Access Compliance Report

Public Rights-of-Way

(Curb Ramps)

Intersection ID: 10037292	Main Street: SARDIS_RD	Cross Street: N/A	Location: E
ADA ID: 64F82AD57EC8	Ramp Type: Perpendicular Diagonal	Initial Pass/Fail: Fail	Overall Compliance: No
			Severity Score: 21.25

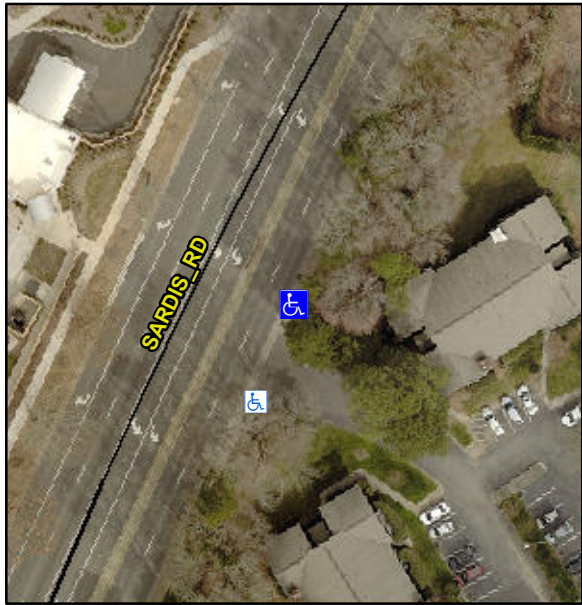
Codes/Mitigation Info/Possible Solution			Field Measurements/Component Compliance							
	Possible Solutions:		Compliance			Description			Data	
	Remove & Replace Curb Ramp With Two New Directional Ramps or Equivalent.		N/A	Ramp Length (in)	59.0	No	Ramp Slope (%)	9.8		
			No	Ramp Width (in)	46.0	Yes	Ramp XSlope (%)	2.0		
			N/A	Flare Type LT	N/A	N/A	Flare Type RT	N/A		
			N/A	Flare Slope LT (%)	N/A	N/A	Flare Slope RT (%)	N/A		
			N/A	Flare Traversable LT?	N/A	N/A	Flare Traversable RT?	N/A		
			N/A	Landing Length (in)	N/A	N/A	DWS Provided?	N/A		
			N/A	Landing Width (in)	N/A	N/A	DWS Contrast?	N/A		
			N/A	Landing Slope (%)	N/A	N/A	DWS Length (in)	N/A		
			N/A	Landing X Slope (%)	N/A	N/A	DWS Full Width?	N/A		
Surveyor Notes:		N/A			N/A	Landing Curb? (Y/N)	N/A	N/A	DWS Offset (in)	N/A
PROW/ADA:		Not Found, R304.5.1, R304.2.2			N/A	Shared Landing?	N/A			
					N/A	Gutter Ponding?	N/A	N/A	Gutter Slope (%)	N/A

N/A	Gutter Lip Ht (in)	N/A	N/A	Gutter X Slope (%)	N/A
					N/A	Painted X Walk1?	No	N/A	Painted X Walk2?	No
						X Walk 1 Direction	To NW		X Walk 2 Direction	To SW
					N/A	X Walk 1 Width (in)	N/A	N/A	X Walk 2 Width (in)	N/A
						X Walk 1 Slope (%)	0.9		X Walk 2 Slope (%)	3.4
						X Walk 1 X Slope (%)	3.8		X Walk 2 X Slope (%)	1.2
Street 1 Name		SARDIS RD		N/A	Ramp inside XWalk1?	N/A	N/A	Ramp inside XWalk2?	N/A	
Stop Condition-Street 2		None			Road Slope (%)	2.0	N/A	Clear Space?	N/A	
Street 2 Name		ENTRANCE			Road X Slope (%)	3.2	N/A	Clear Space to XWalk (in)	N/A	
Stop Condition-Street 1		None		N/A	Any Obstructions?	N/A	N/A	Storm Grate/Utility Hazard?	N/A	
						Obstruction Type		Storm Grate/Utility Type		
							N/A		N/A	
							Yes	Surface Condition? (G/P)	Good	
Total Cost:		\$ 3200.00
